DATE: January 19, 2023
TO: Emily Meharg (City of Sandy)
FROM: Todd Prager, RCA #597, ISA Board Certified Master Arborist
RE: Tree Preservation and Removal Review for 38105 Highway 26

This memorandum is a summary of my review of the tree preservation and removal plan for the mixed-use development proposal at 38105 Highway 26 in Sandy, Oregon.

L1.1

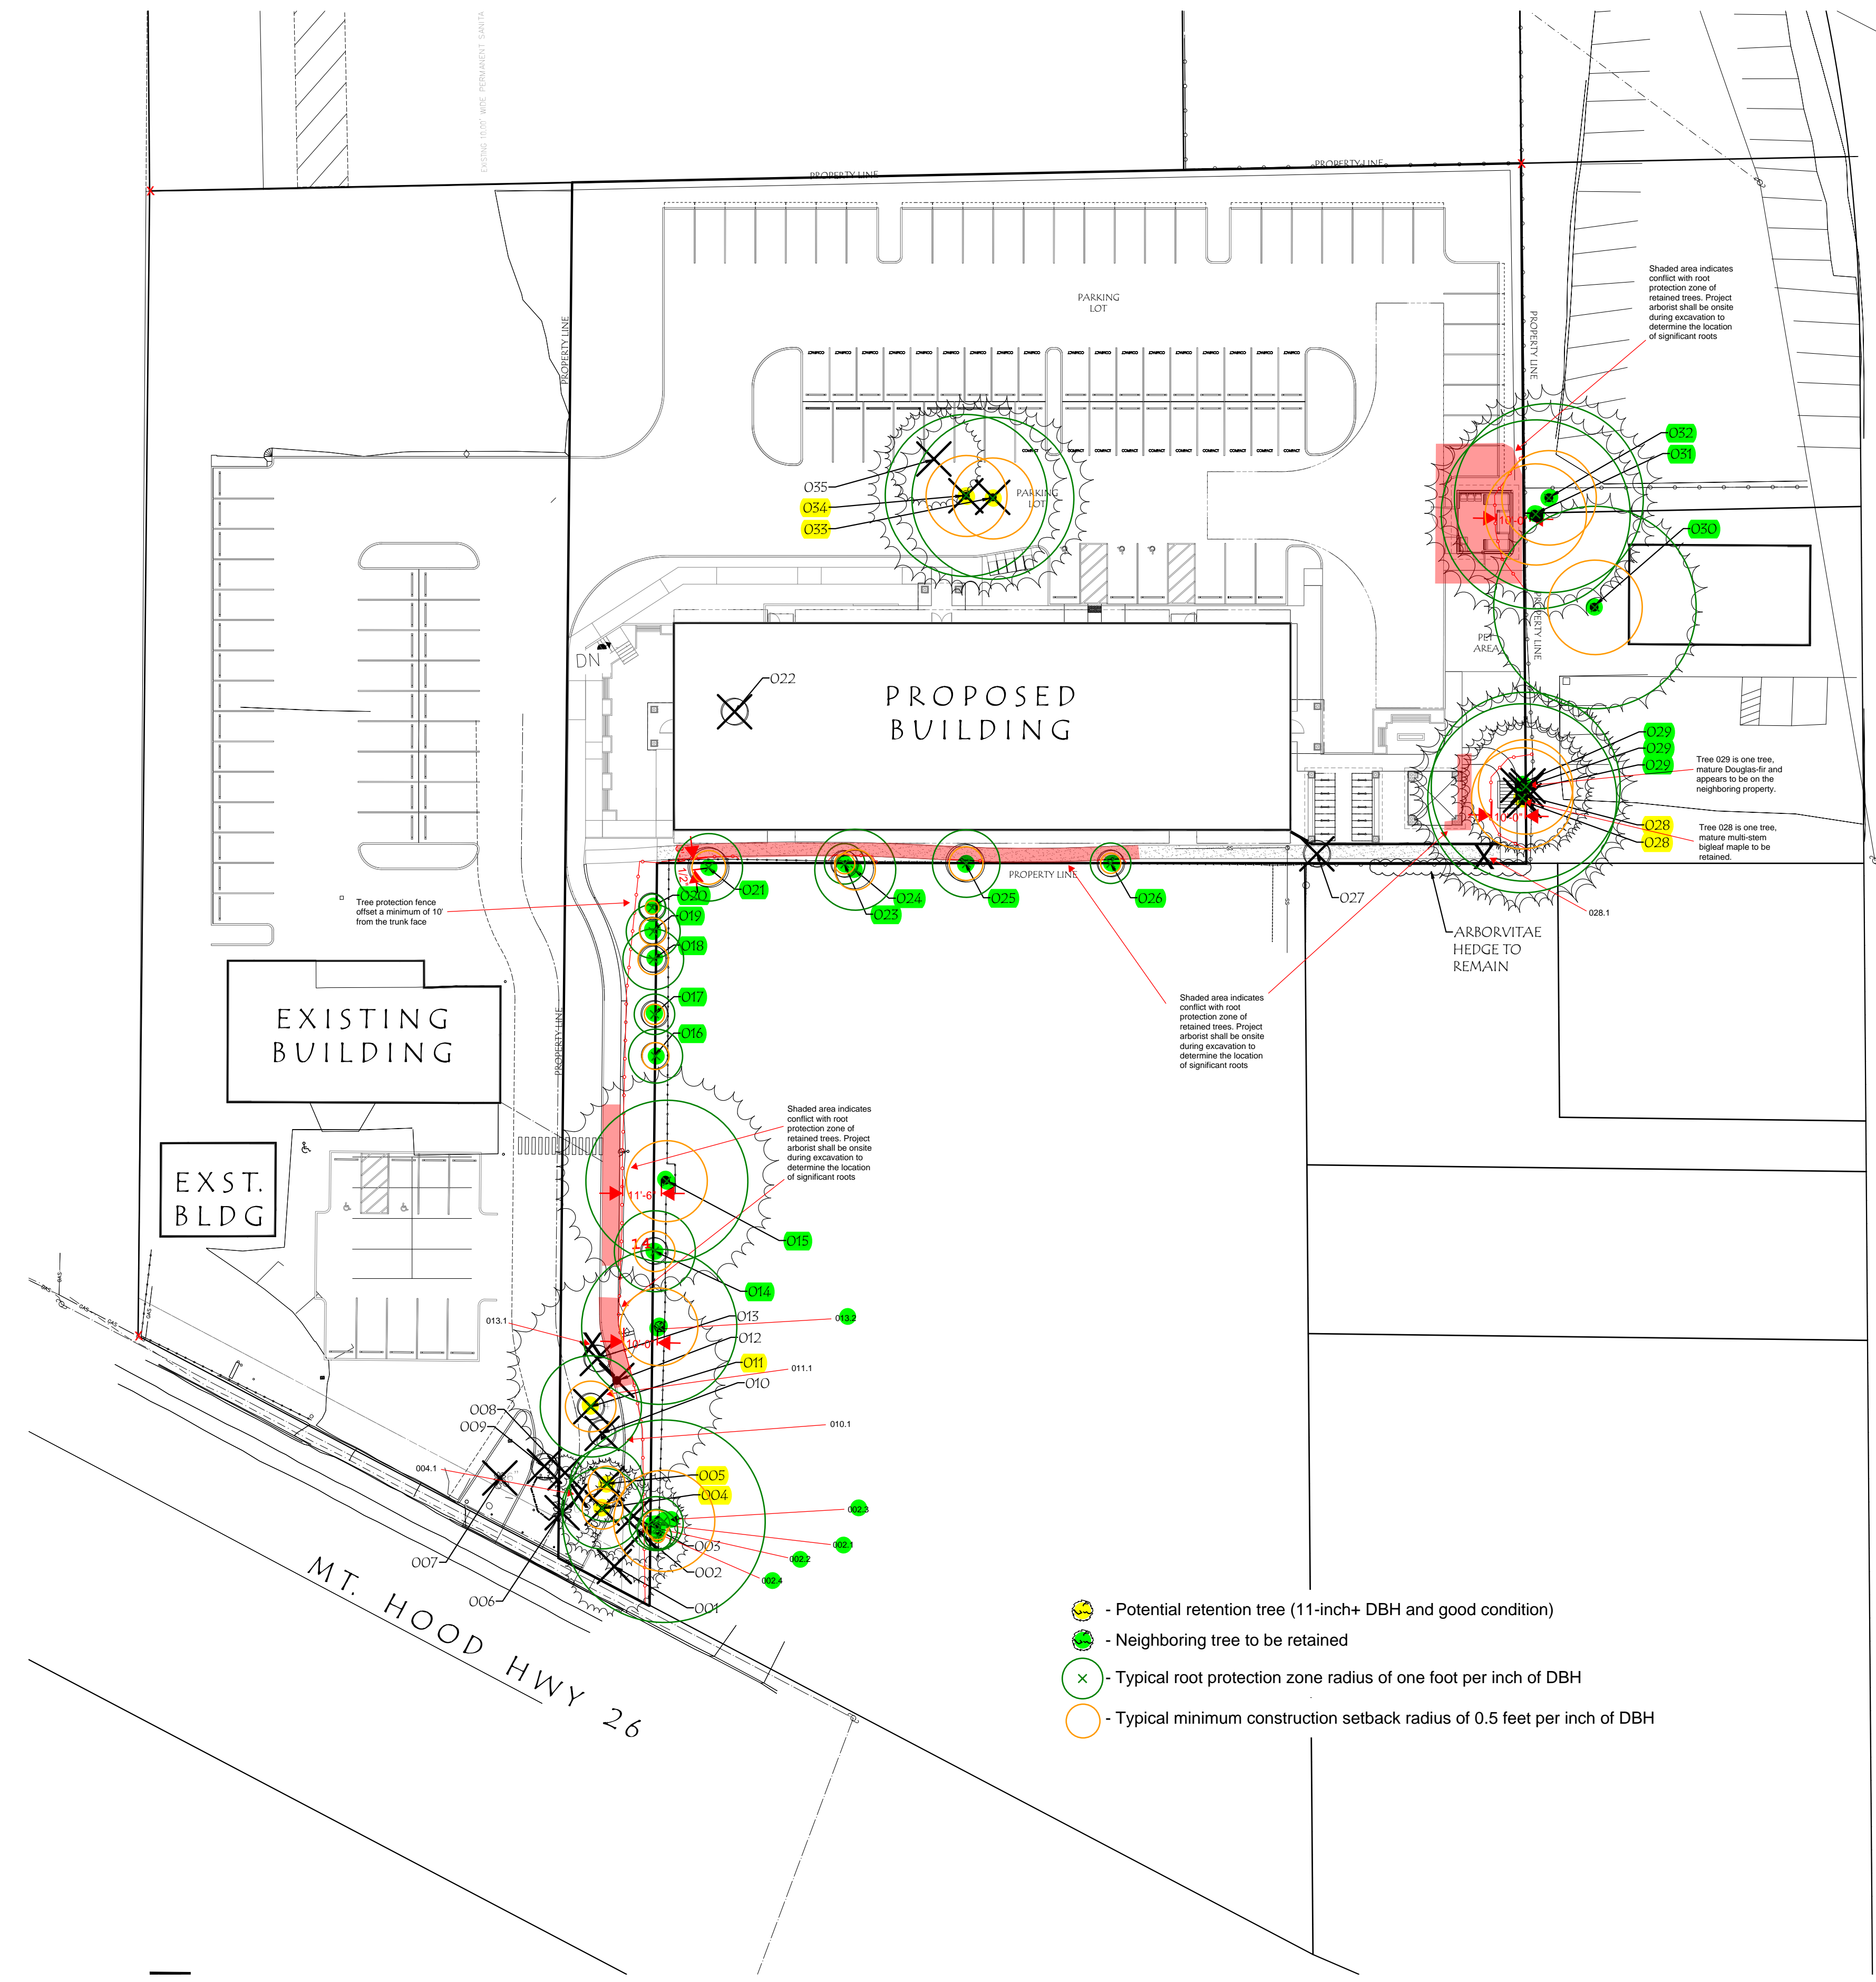
I identified 21 trees on adjacent properties that are proposed to be retained and protected with development. These trees are highlighted in green on pages 7 through 9 of the arborist report and on sheets 2, 3, and L1.1 in the plan set in Attachment 2. The City of Sandy requested my recommendations on how to minimize the negative impact to these trees on adjacent properties.

I included the typical root protection zone radii and typical minimum construction setback radii for the trees on neighboring properties to be retained on page 9 of Attachment 1 and sheets 2, 3, and L1.1 in the plan set in Attachment 2. In reviewing the proposed construction in relation to the typical minimum protection zones in Figure 1, there are 12 neighboring trees that do not meet the Figure 1 minimum tree protection zone (trees 2.1, 2.3, 13.2, 15, 21, 23, 24, 25, 26, 29, 31, and 32).

Trees 2.1, 2.3, and 13.2: Consider shifting the pedestrian pathway so it is directly adjacent to the driveway alignment at the driveway entrance adjacent to trees 2.1 and 2.3. Also, consider shifting the entire driveway further from all three trees if allowed by ODOT.

Trees 21, 23, 24, 25, and 26: Trees 21, 24, 25, and 26 are nuisance species (sweet cherry, *Prunus avium*). Consider discussing removal with the tree owner rather than protecting this low value species. If the owner does not want to remove these trees, determine whether the sidewalk can be constructed without disturbing the existing grade as recommended by the project arborist. Alternative sidewalk materials should be considered if they would be less impactful to the trees' root zones. The sidewalk may also be meandered further from these trees, and potentially avoid the typical minimum construction setback radius of tree 23.

COMPOSITE SITE PLAN
MIXED USE SITE DEVELOPMENT
38015 HWY 26, SANDY, OR 97055

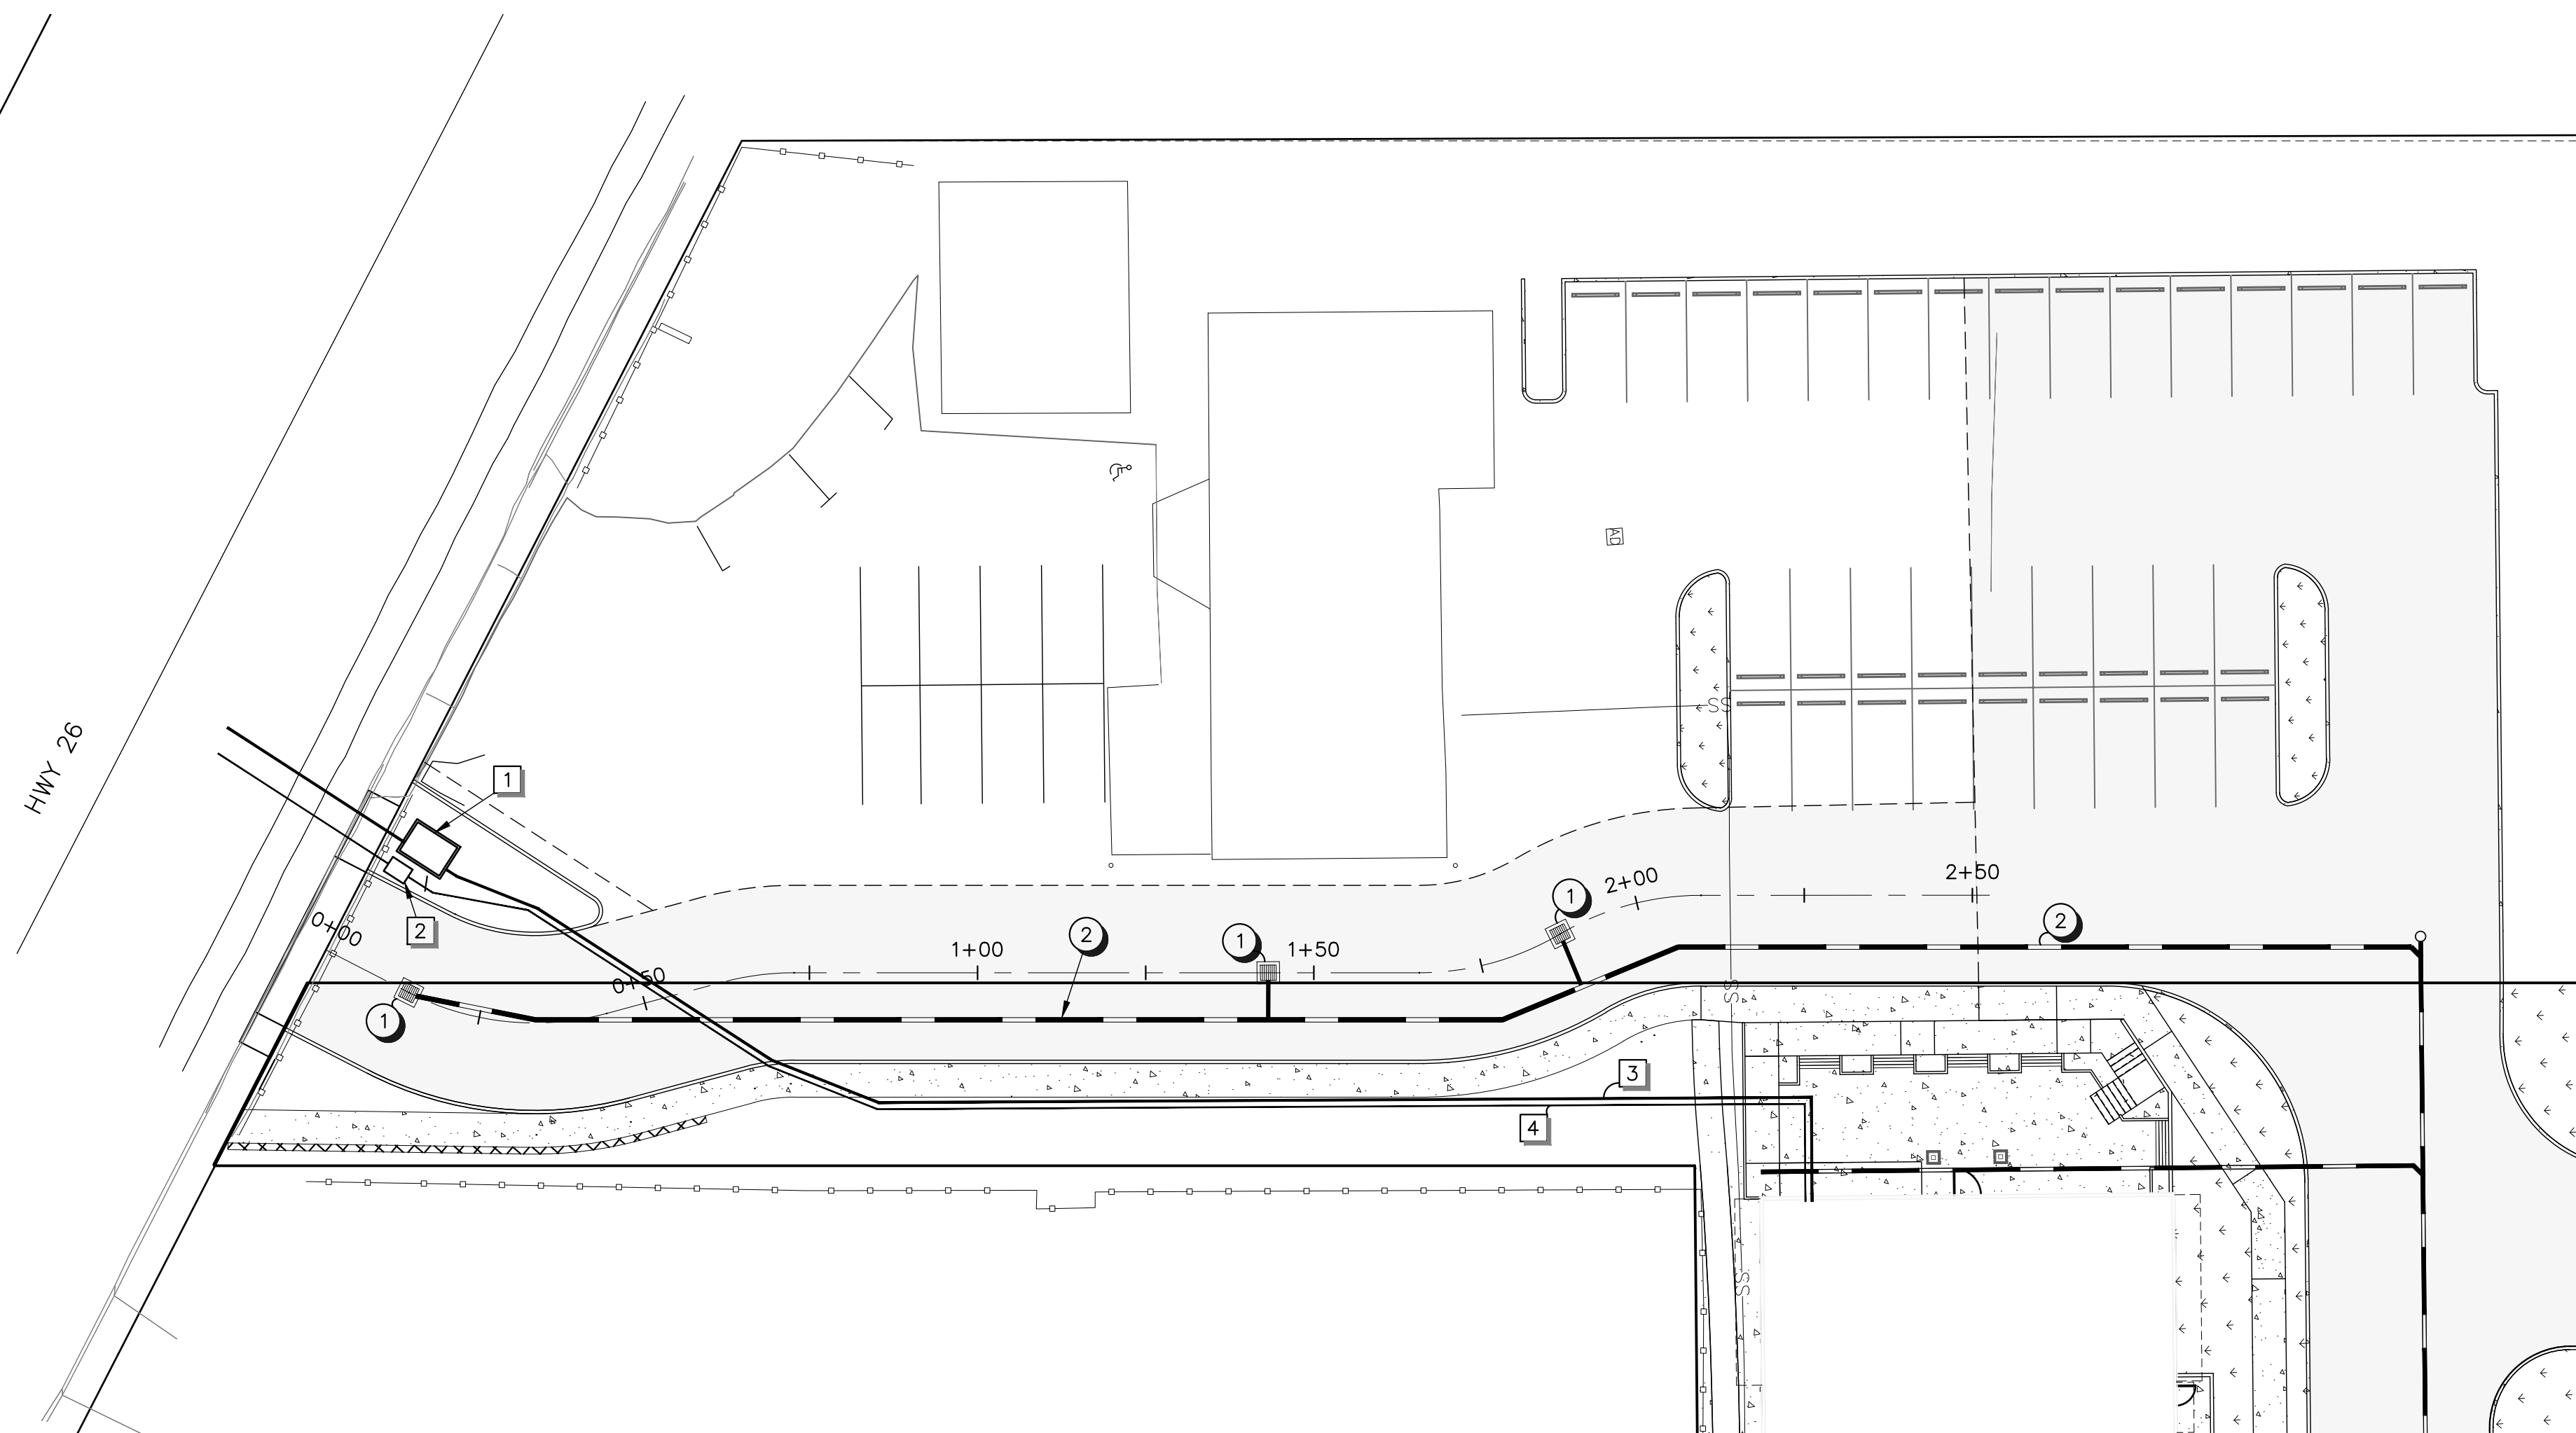
Trees 29, 31, and 32: These trees have the greatest potential to be impacted based on the sizes of the root zones and proximity of grading or retaining walls. Consider whether a retaining wall could be used to prevent grading within the typical minimum construction setback radius of tree 29. For trees 31 and 32, consider removing the parking space closest to the tree and shifting the retaining wall to the edge of the parking lot and driveway access to avoid the typical minimum construction setback radii of the trees.
